5.2 Integrity of Reactor Coolant Pressure Boundary

The information in this section of the reference ABWR DCD, including all subsections, tables, and figures, is incorporated by reference with the following departures and supplements.

STD DEP T1 2.1-1 (Table 5.2-3, Figure 5.2-2, replaced entire figure)

Figure 5.2-2 MSIV Closure with Flux scram and Installed Safety / Relief Valve Capacity

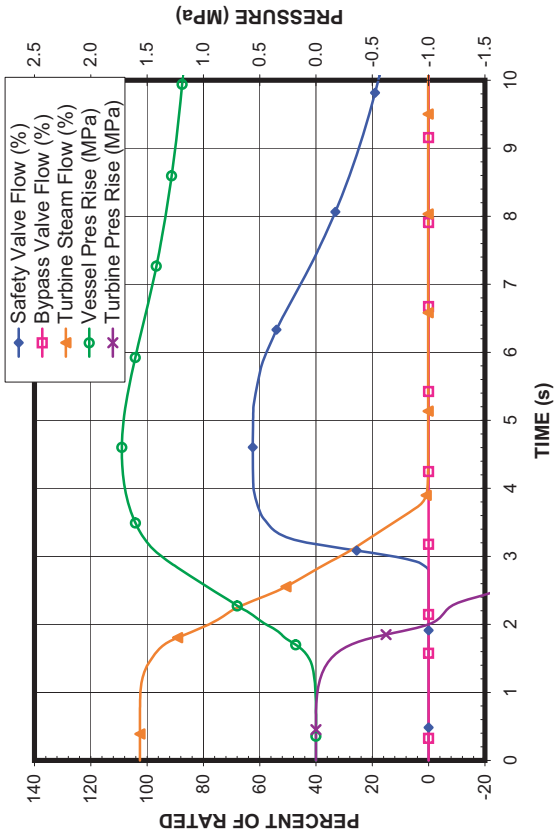
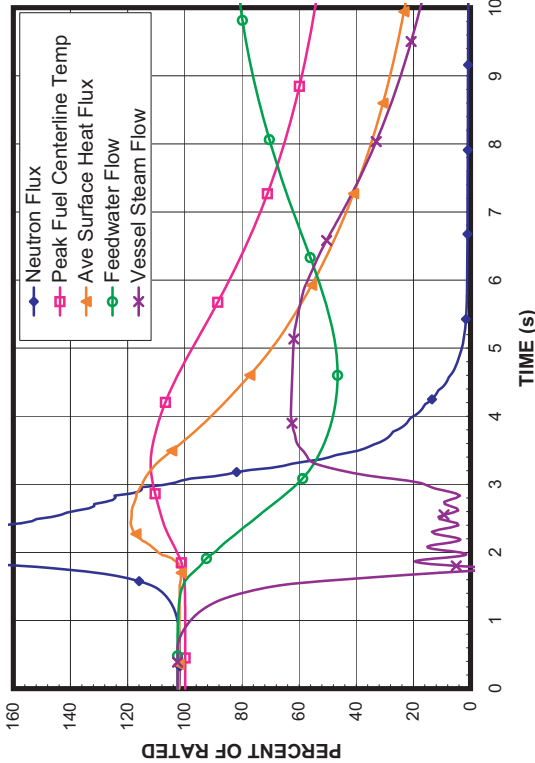
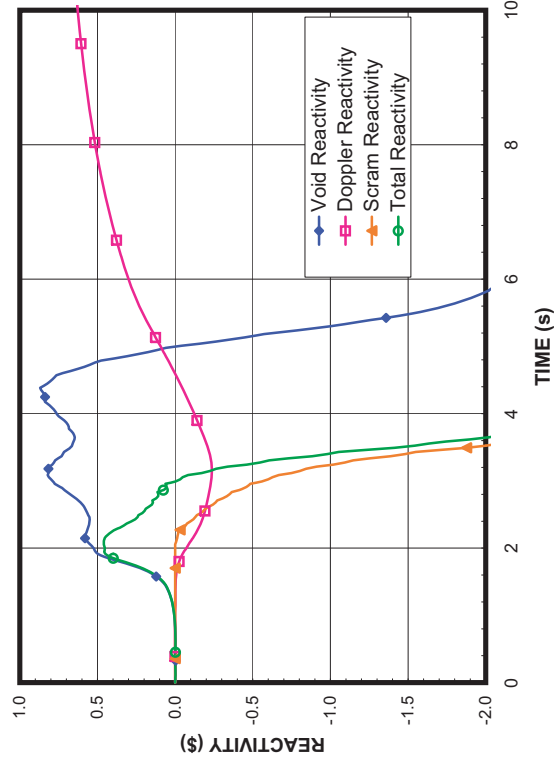
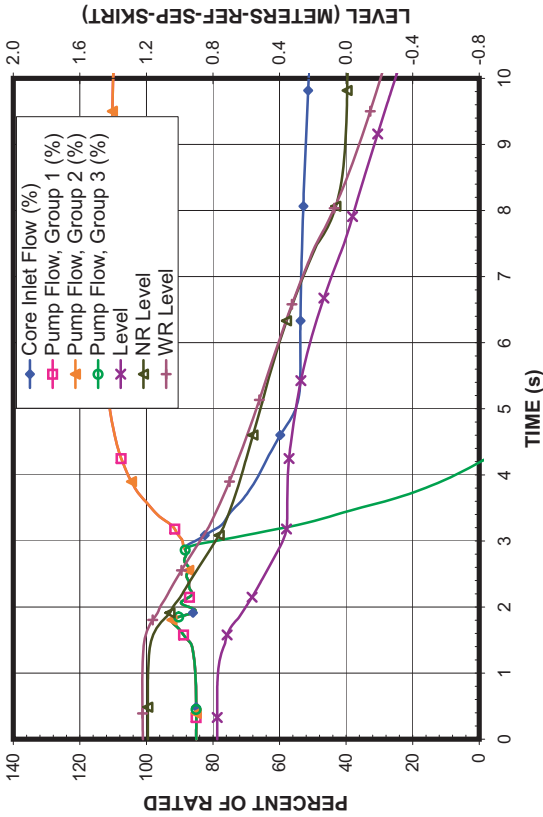
The required SRV capacity is determined by analyzing the pressure rise from an MSIV closure with a flux scram transient. Results of this analysis are given in Figure 5.2-2. The peak vessel bottom pressure calculated is ~~8.79~~ 9.09 MPaG, which is well below the acceptance limit of 9.48 MPaG. The results show that only 12 valves are required to meet the design requirement with adequate margin. The analysis assumes one of the 12 SRVs fails on demand.
